ZONING BOARD OF APPEALS MEETING

LOCATION: TOWNSHIP ANNEX, 7527 HIGHLAND ROAD, WHITE LAKE, MICHIGAN, 48383
(FORMER WHITE LAKE LIBRARY)
THURSDAY, APRIL 28, 2022 – 7:00 PM

RE: Hypershine Auto Wash
Preliminary Site Plan and Special Land Use – Review #2

Staff reviewed the revised site plan prepared by Stonefield Engineering & Design (revision date March 16, 2022). The following comments from the first review dated February 18, 2022 are listed below. Responses to those comments are provided in **(red)**.

DATE 02-17-22 SHEET No. 1 SCALE 1"=30'

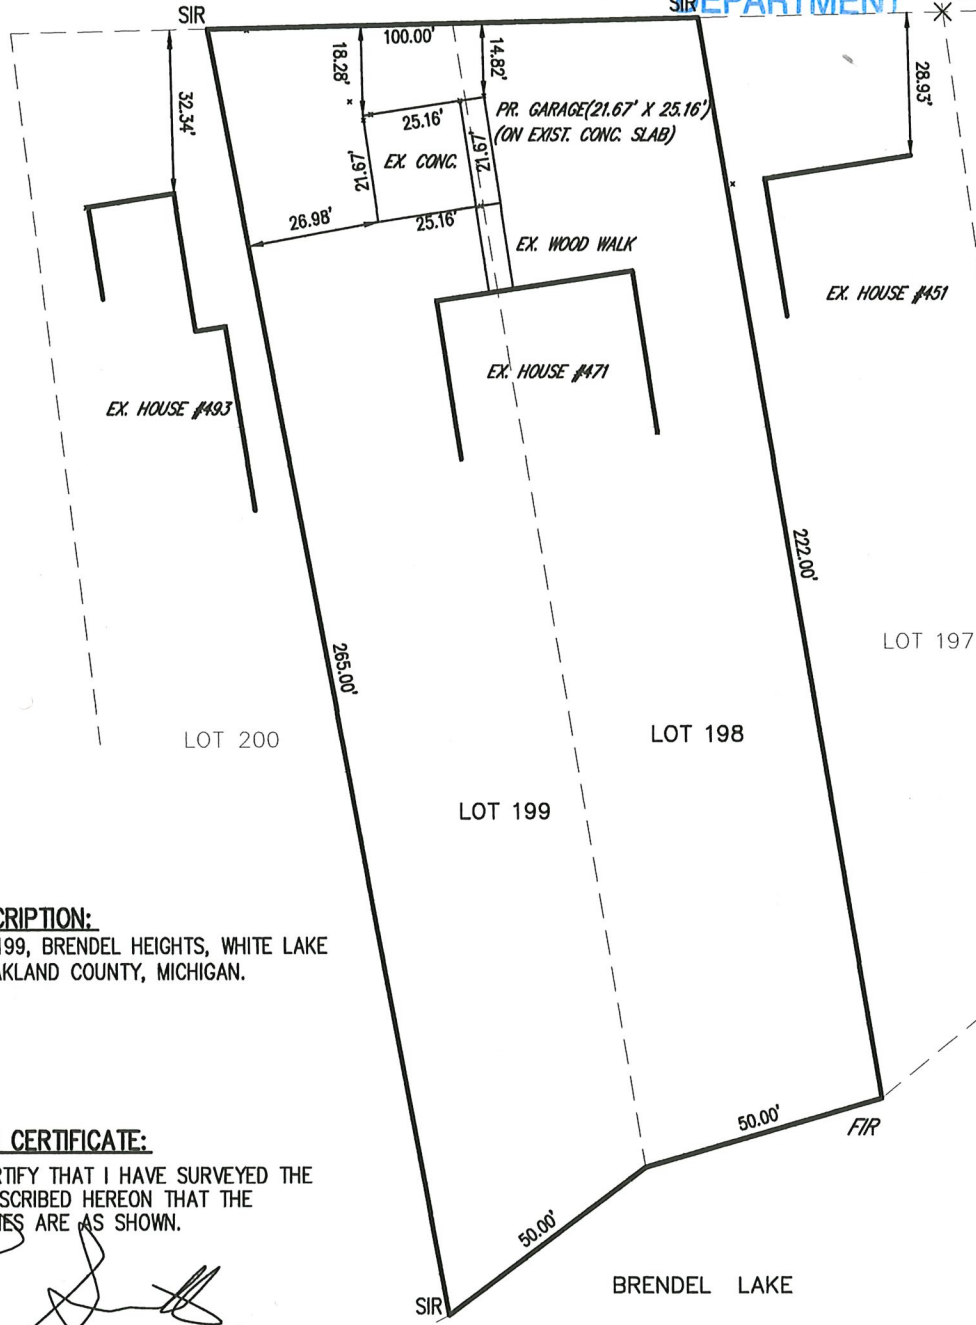
The proposed accessory building (detached garage) would be located 14.82 feet from the front property line; therefore, the applicant is requesting to encroach 15.18 feet into the front yard setback (30 feet in the R1-D zoning district). Note the architectural plans do not scale to the building dimensions labeled.

ACCESSIBLE PARKING STALL MARKINGS
NOT TO SCALE

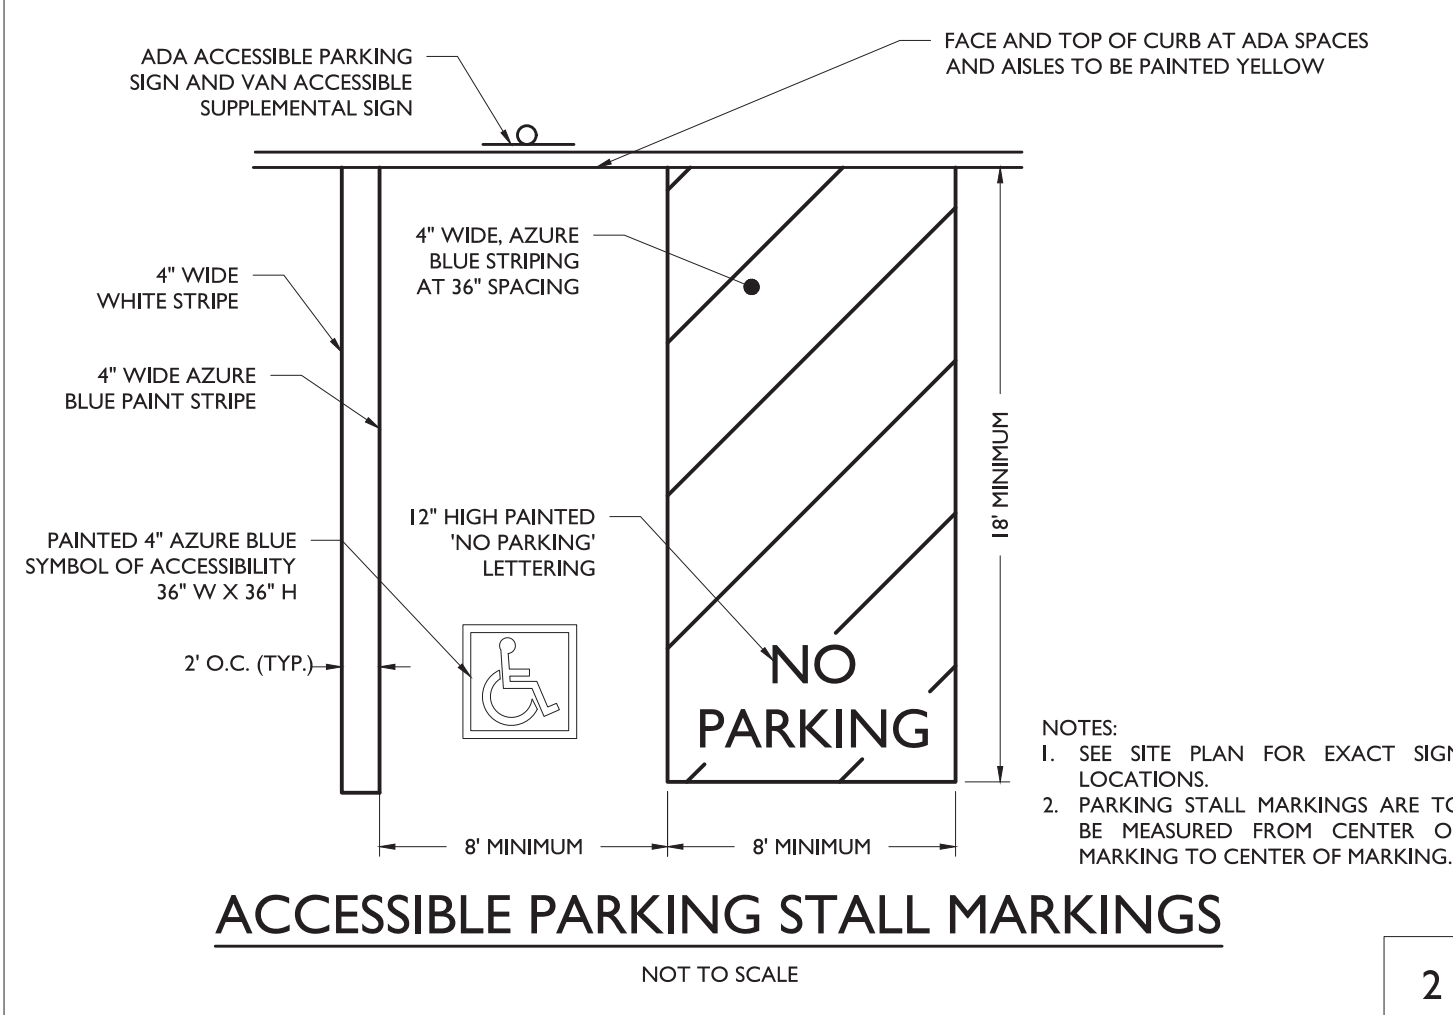
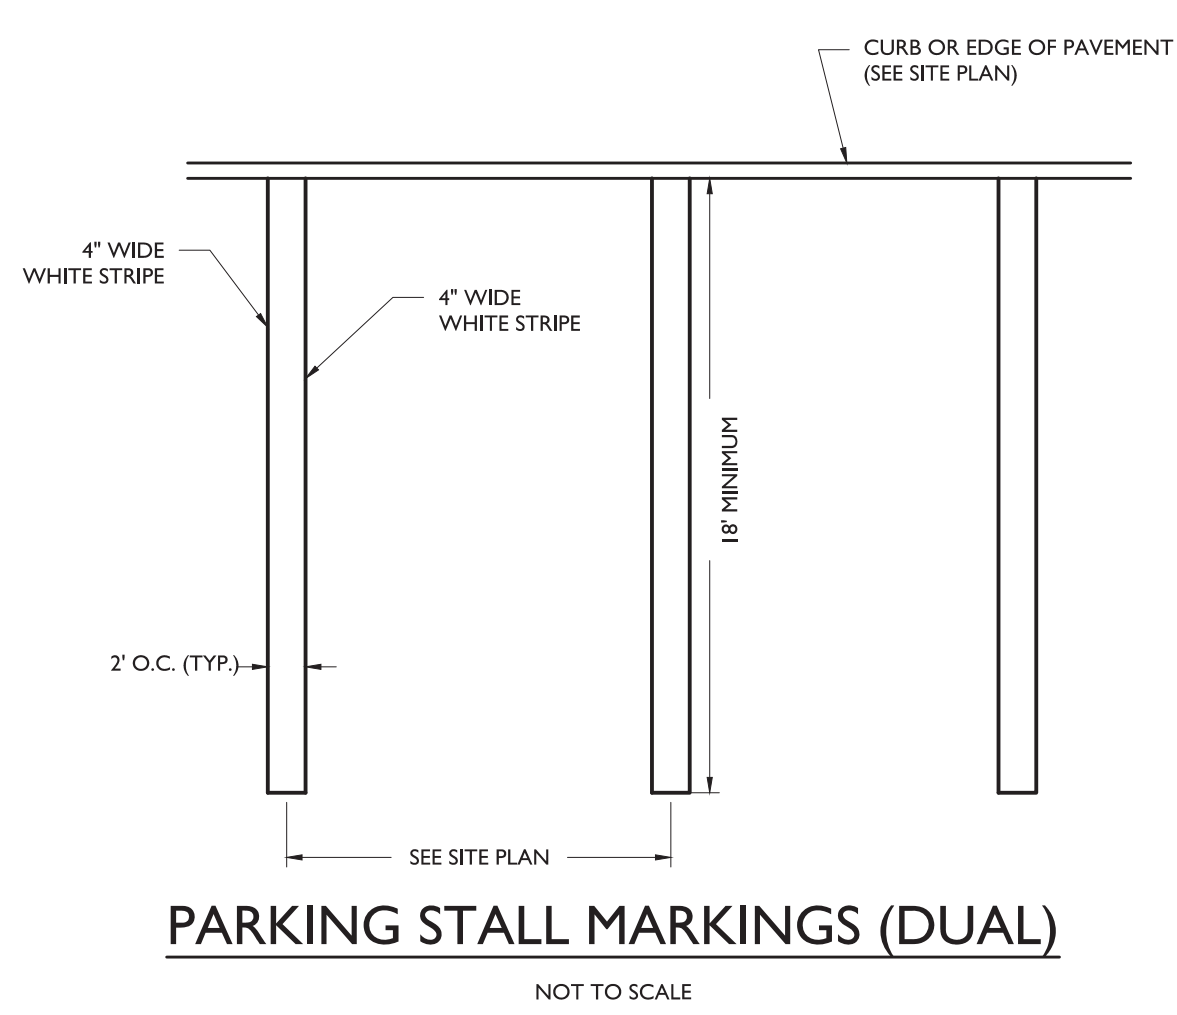
The accessible parking stall detail on Sheet C-8 is inconsistent with the dimensions on the site plan, which shows a three-foot-wide access aisle west of the barrier-free space. In accordance with the zoning ordinance and Americans with Disabilities Act (ADA), the adjacent access aisle shall be eight-feet-wide. The plan shall be revised accordingly. (Comment addressed. ADA accessible space and standard detail has been revised to comply with ADA requirements. **The zoning ordinance also requires each individual parking space be delineated by dual stripes, two feet apart centered on the dividing lines and painted white. The plan (including the parking stall markings detail) shall be revised accordingly to indicate the required striping.** (Comment addressed. Parking stall striping and detail has been revised to provide dual striping).

TRASH / RECYCLE ENCLOSURE DETAIL
NOT TO SCALE

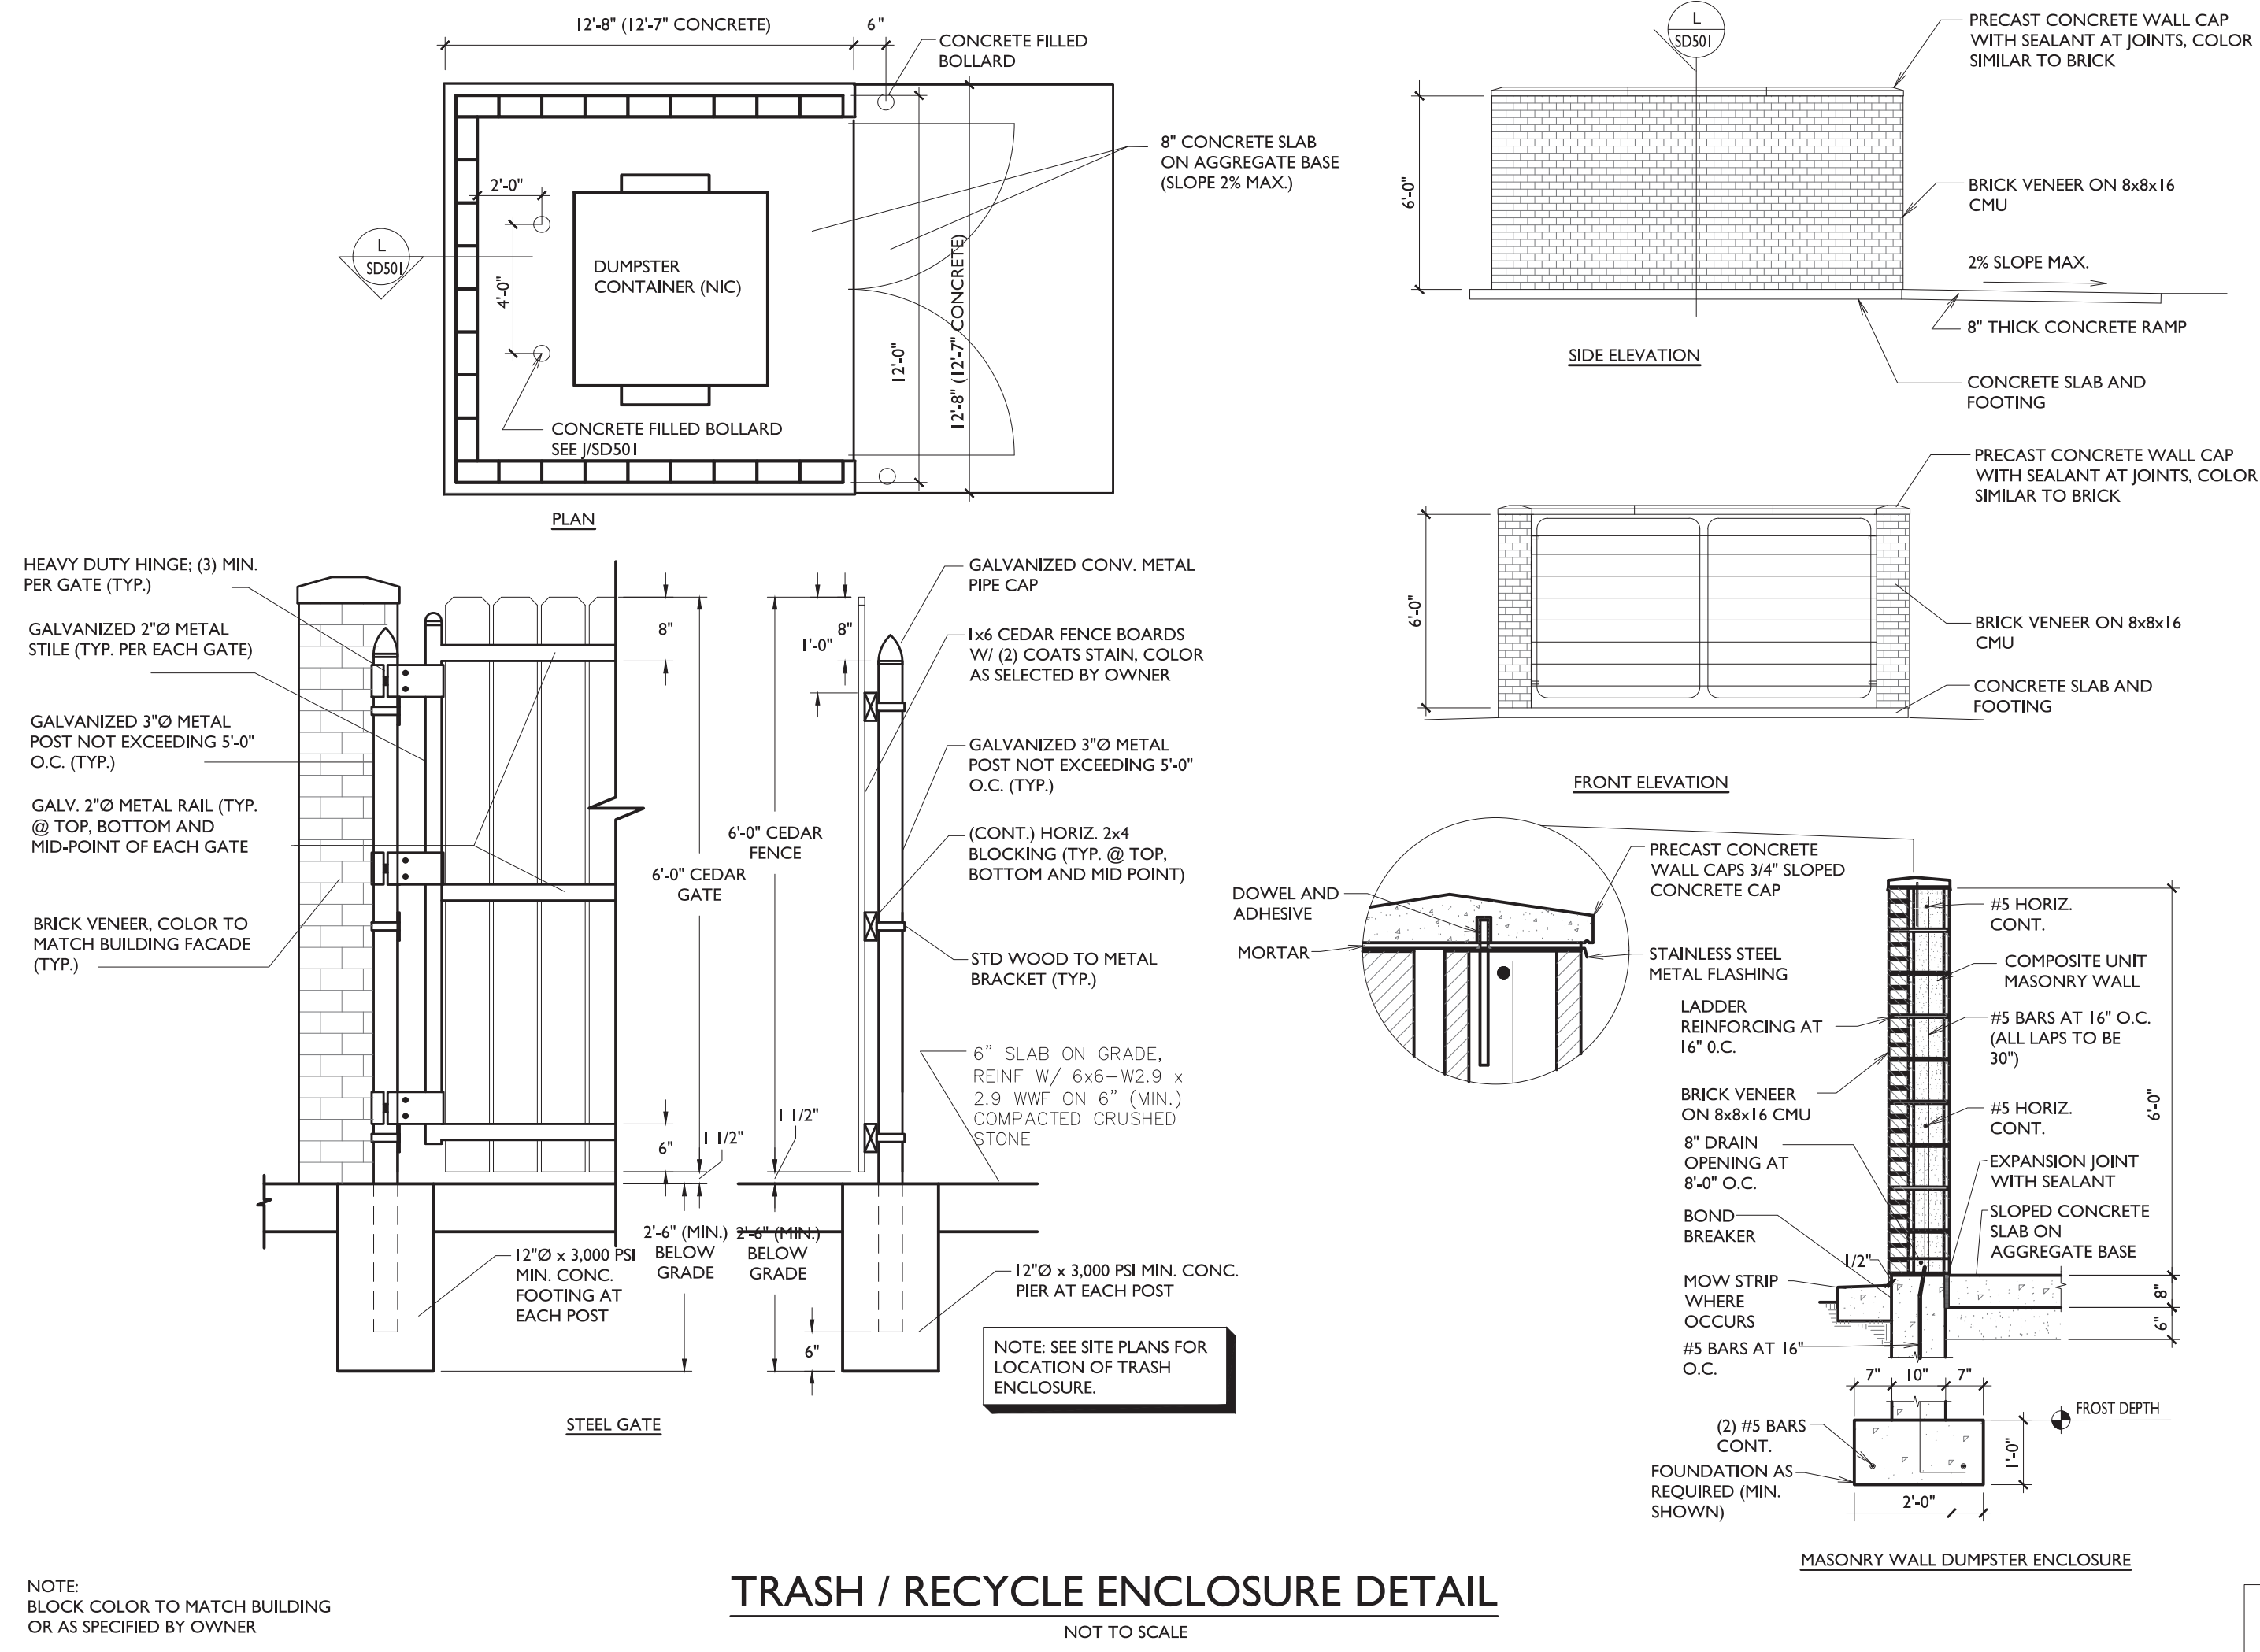
The zoning ordinance requires dumpsters to be surrounded by a six-foot-tall to eight-foot-tall wall on three sides and an obscuring wood gate on a steel frame on the fourth side, located on a six-inch concrete pad extending 10 feet in front of the gate, with six-inch concrete-filled steel bollards to protect the rear wall and gates. **The bollards for the dumpster enclosure shown on Sheet C-8 shall be six-inch diameter instead of four-inch diameter, and bollards shall be provided six inches in front of (north) of each gate post.** (Comment addressed. Bollard detail has been revised from four-inch to six-inch bollards. Trash enclosure detail has been revised to show bollards six-inches from front gate posts). The proposed enclosure is located north of the building. The zoning ordinance prohibits trash enclosures within a required front yard setback, and does not allow enclosures closer to the front lot line than the principal building. The proposed dumpster enclosure is located closer to Highland Road than the automobile wash building, and does not meet the front yard setback. As proposed, **the following variances are required from the Zoning Board of Appeals: an 89-foot variance to project into the front yard, and a 10-foot variance to encroach into the front yard setback.** (Comment partially addressed. The trash enclosure detail was shifted south out of the front yard setback. However, the trash enclosure is projecting approximately 81.3 feet into the front yard (Sheet C-2 shall be revised to measure the projection to the northern extent of the trash enclosure). The applicant intends to seek a variance from the Zoning Board of Appeals).

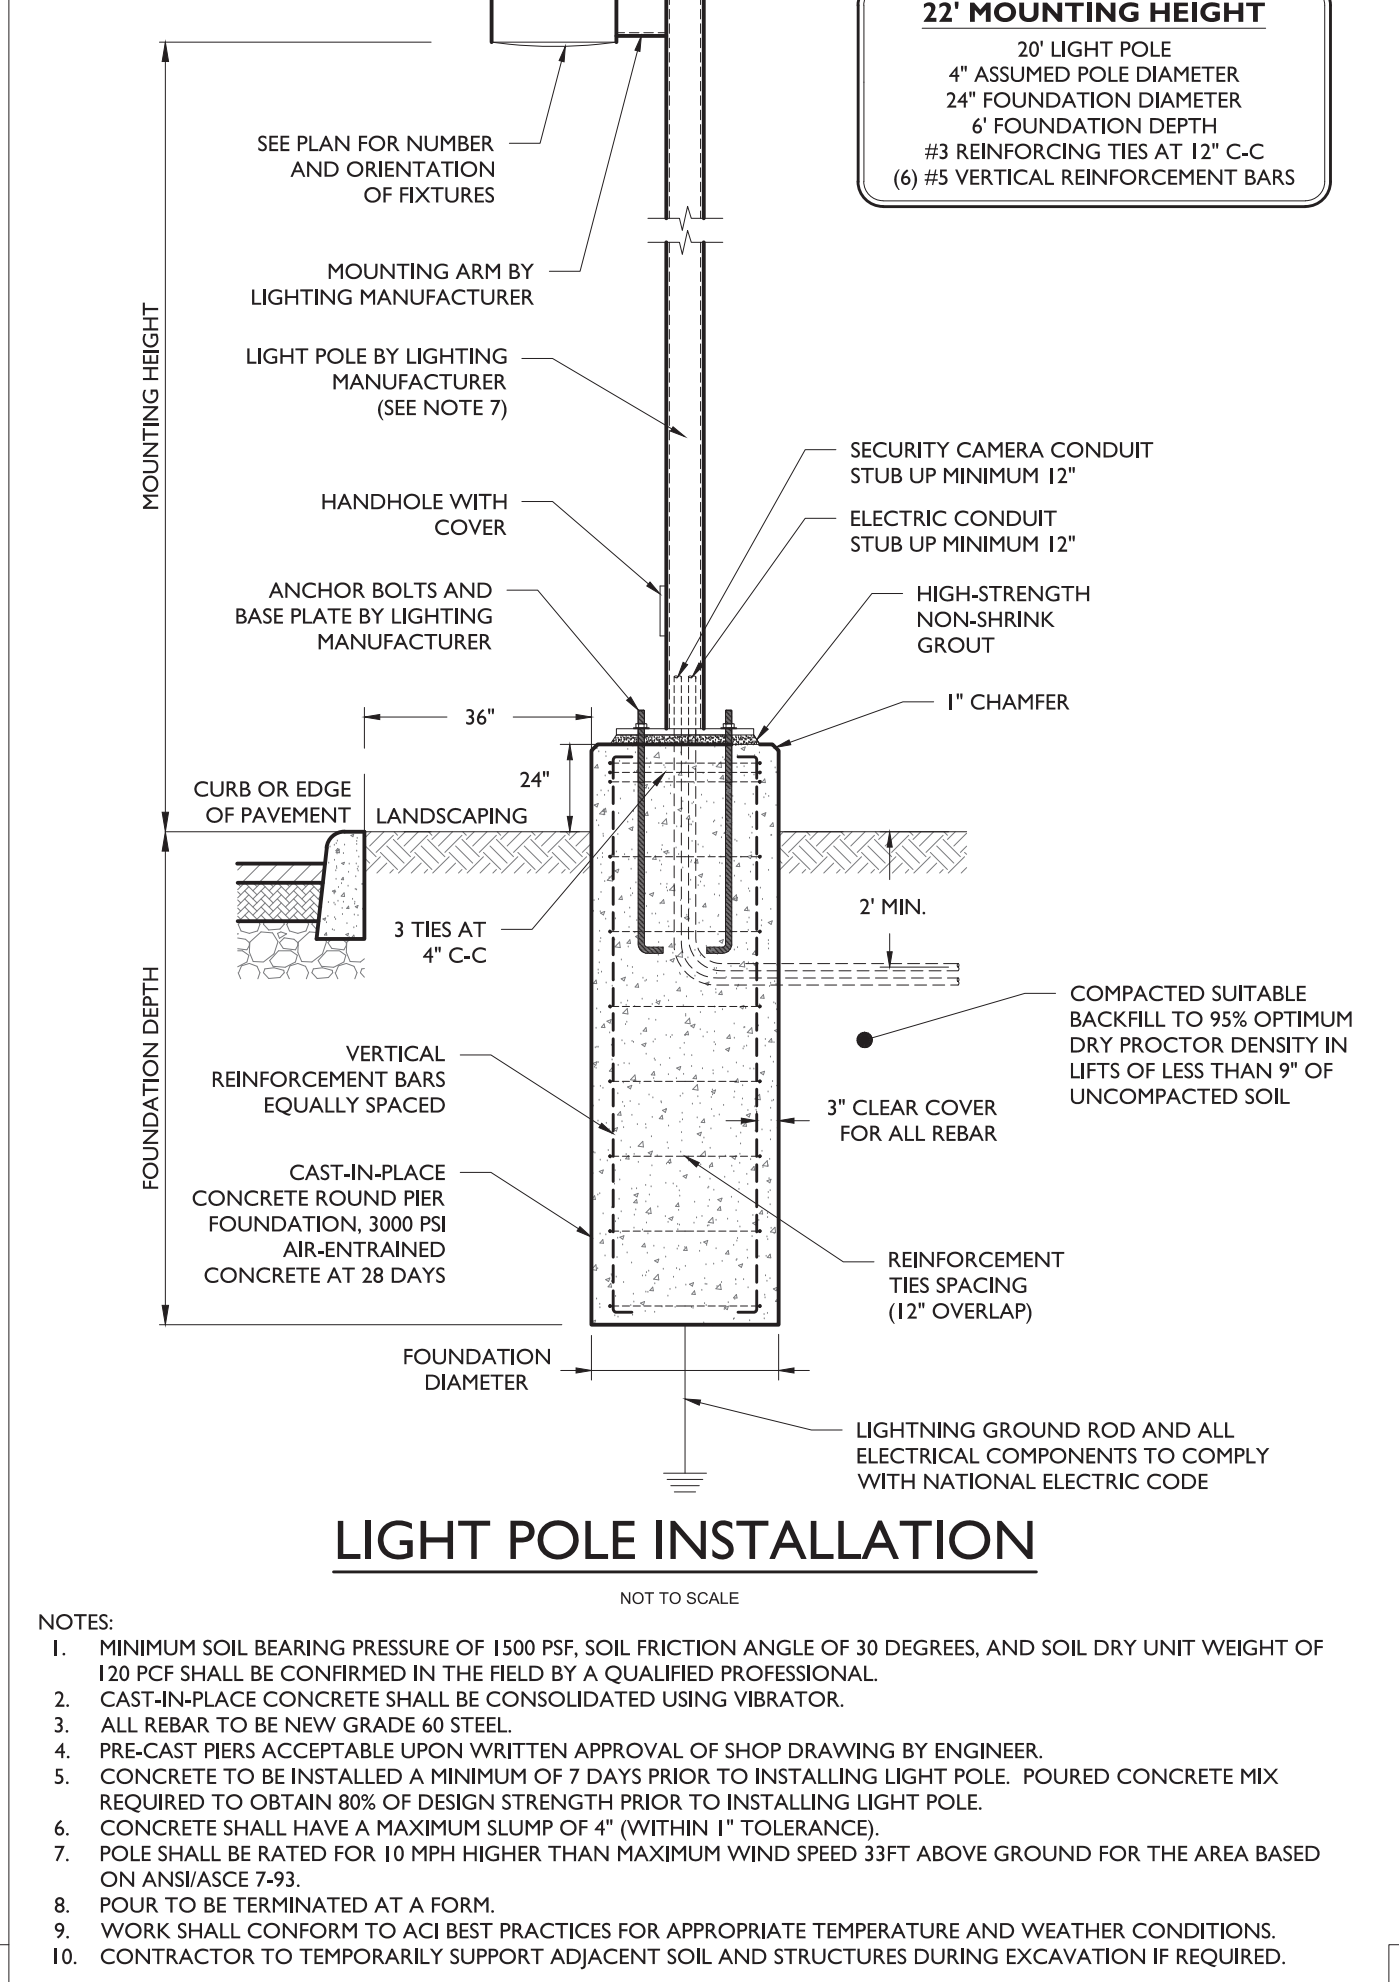
- **Complete catalog details (lighting fixture specification sheets) for all proposed fixtures shall be provided. Light fixture selections and colors are subject to review and approval by the Township. (Comment partially addressed. Partial lighting fixture specifications have been provided on Sheet C-10. Complete catalog details shall be submitted separately at final site plan).**
